SUBJECT: CENAP-OP-R-200300700-11

Reference is made to Department of the Army permit CENAP-OP-R-200300700-11 dated February 26, 2007 authorizing you to perform work, including the discharge of dredged or fill material, in waters of the United States, including wetlands, to facilitate construction of the Delaware Turnpike (Interstate 95) Mainline/SR 1 Interchange Project within and adjacent to the Christina River, New Castle County, Delaware.

EXHIBIT A

CATHCART CONSERVATION AREA

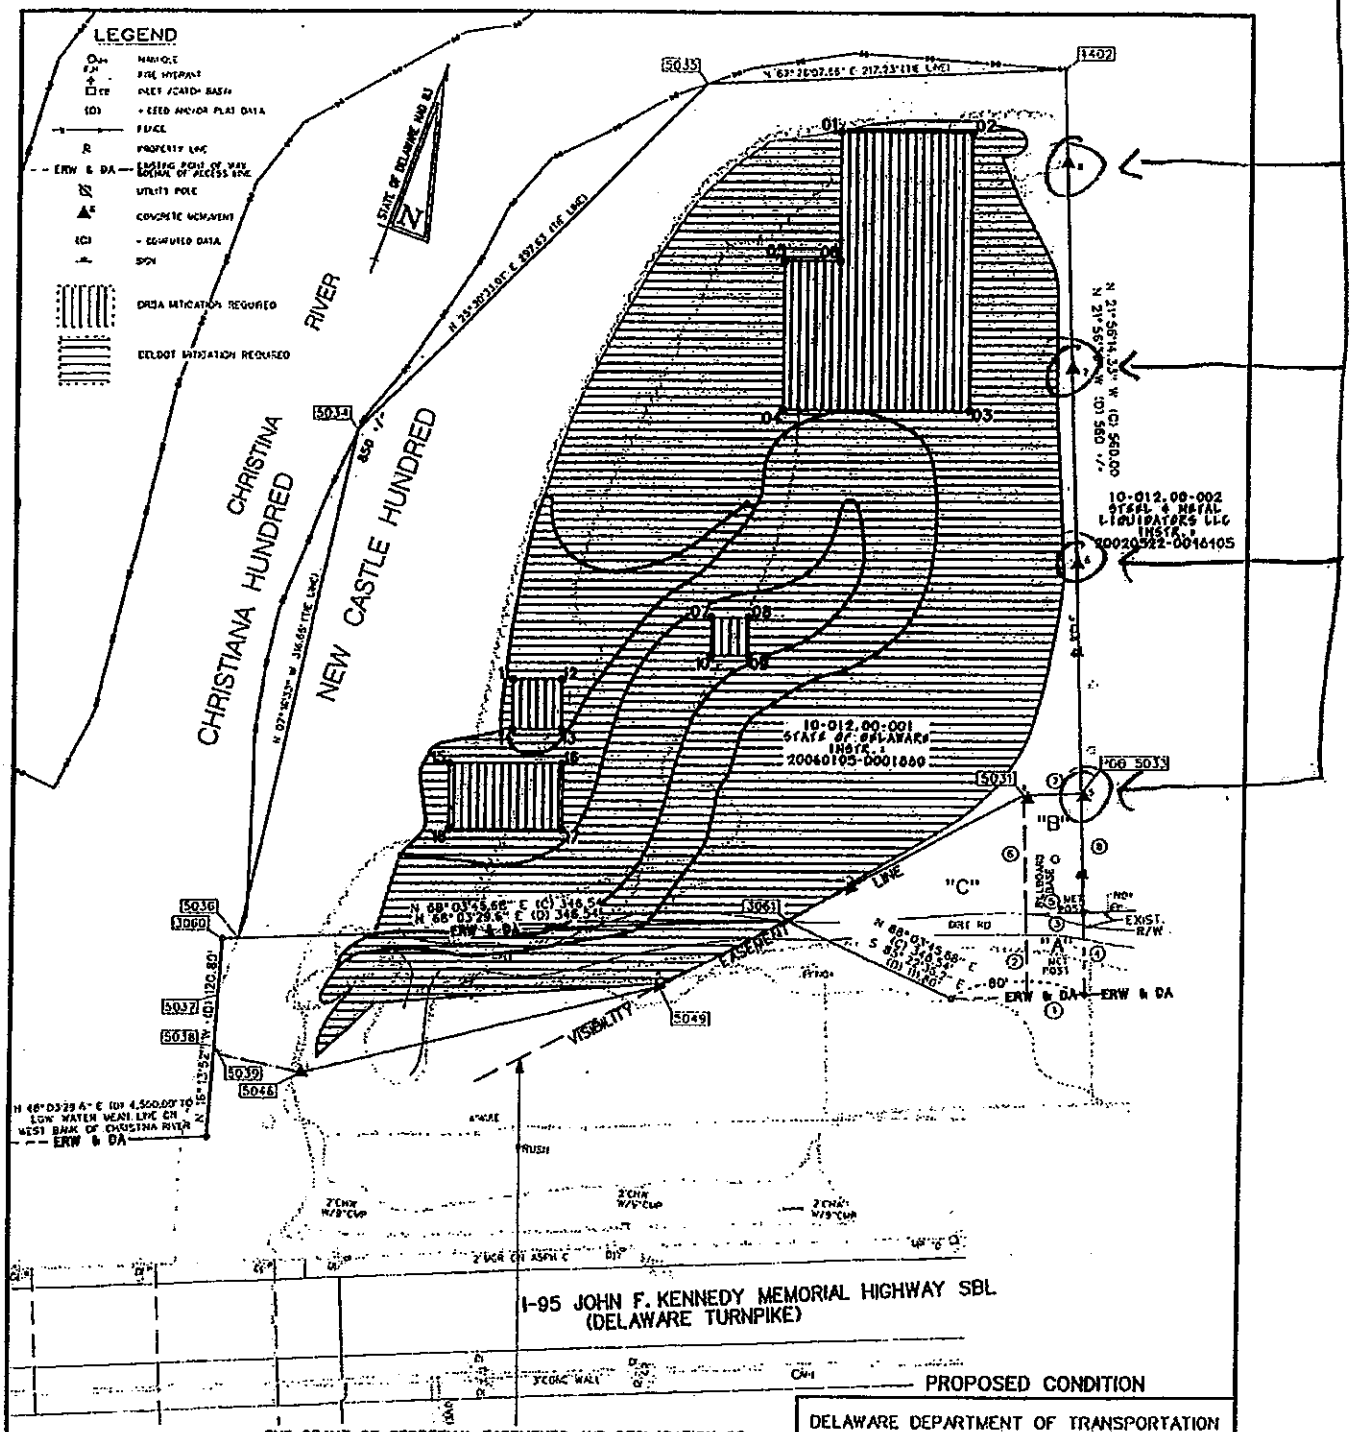
According to a letter from your consultant, RK&K, an existing fence has created a conflict with your ability to install Monuments 5 through 8 at the locations shown on the previously approved mitigation plans (Enclosure 1). RK&K has requested, on your behalf, the ability to modify the proposed location of the monuments to avoid the fence conflict (Enclosure 2).

Monuments to Be Moved

This office has no objection to the proposed changes to the locations of Monuments 5 through 8 provided:

1. All work is performed in accordance with the protocol established in Enclosure 1 and consistent the monument location information provided in Enclosure 2.

2. All work identified in Steps 1 through 6 in Enclosure 1, including the re-recording of the revised conservation easement, shall be completed within 60 days of the date of this letter.

3. The permittee shall submit documents generated as a result of implementing Steps 3 and 4 identified in Enclosure 1 to this office for review and approval prior to re-recording the conservation easement with the revised exhibits.
